P1 Project Drawing Updates - 10/24/2019

BR-549-A-002

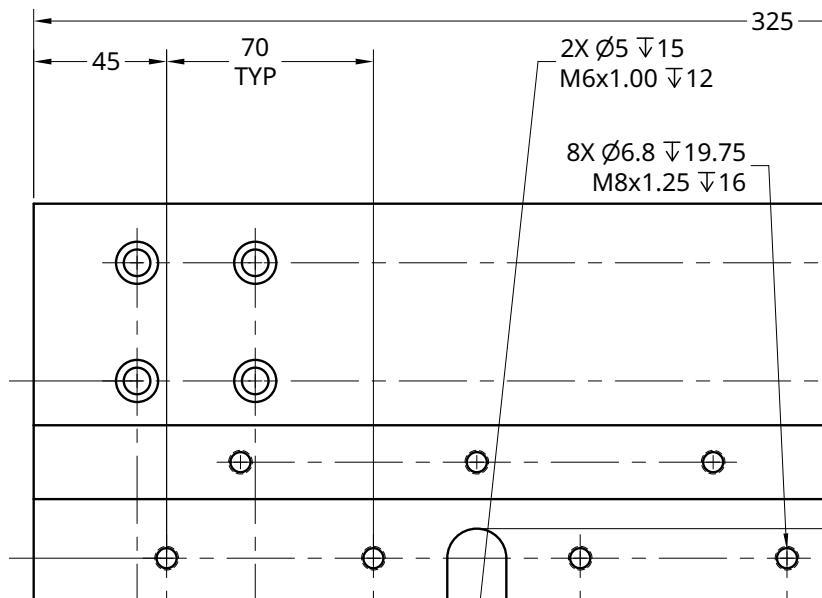
Groove diameter was missing. Also there are 7 (not 6) 0.5 x 45° chamfers.

BR-549-B-001

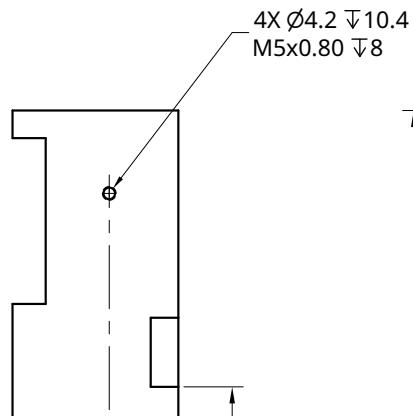
4 holes were missing hole callouts

BR-549-B-006

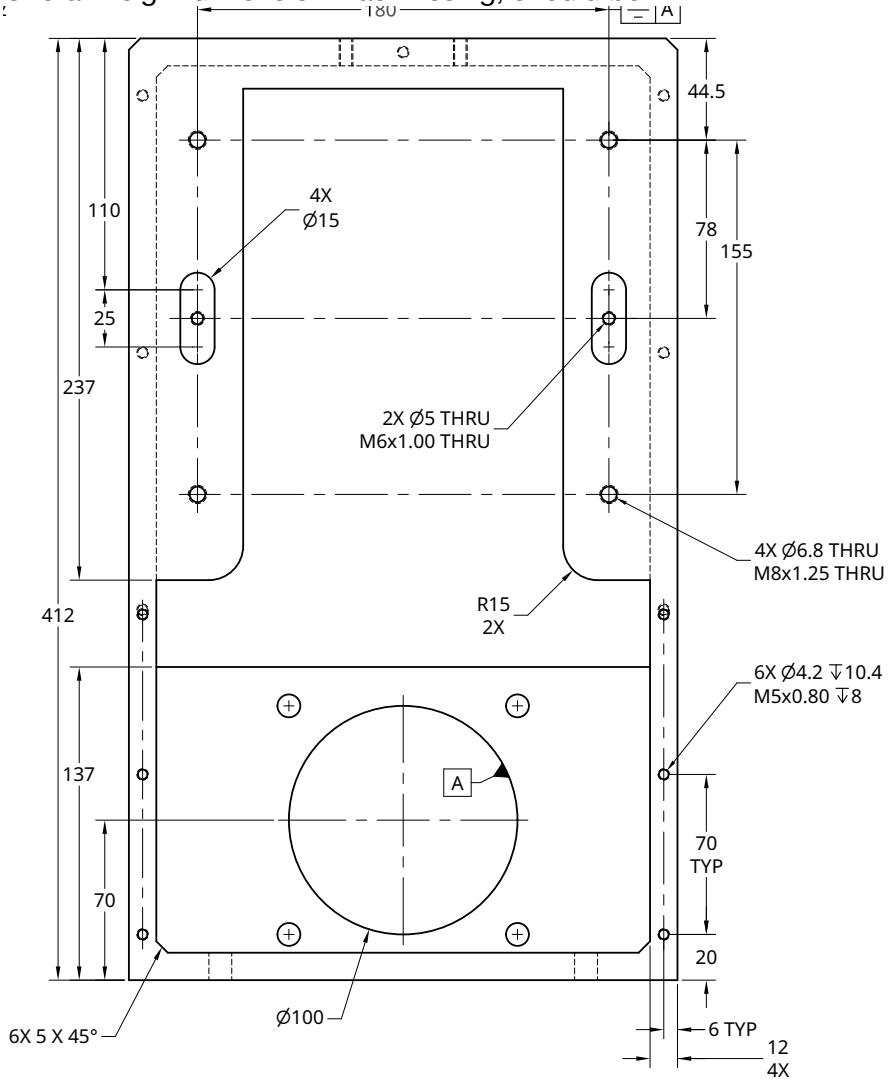
Overall height dimension was missing; should be 412

BR-549-C-001

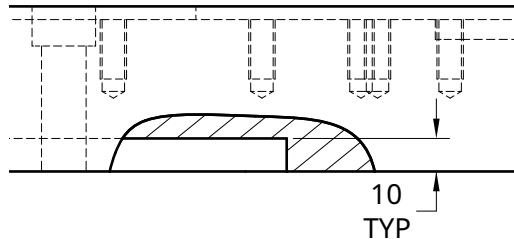
Keyway depth dimension was missing

BR-549-C-003

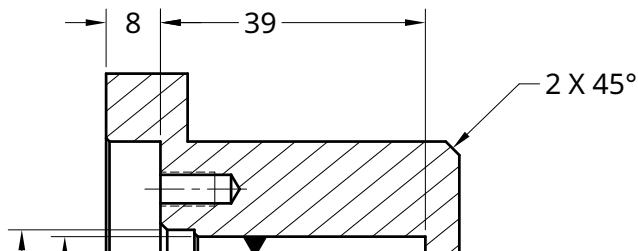
Chamfer dimension was missing

BR-549-C-011

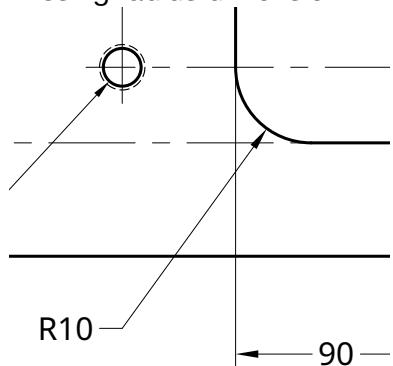
Missing radius dimension

BR-549-B-001

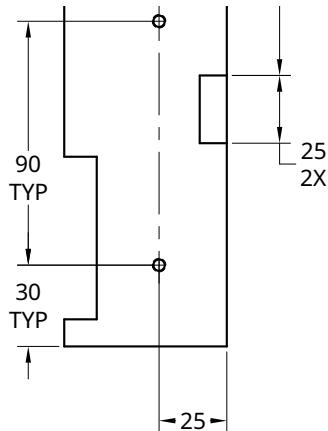
Added TYP to 30 dimension as shown below
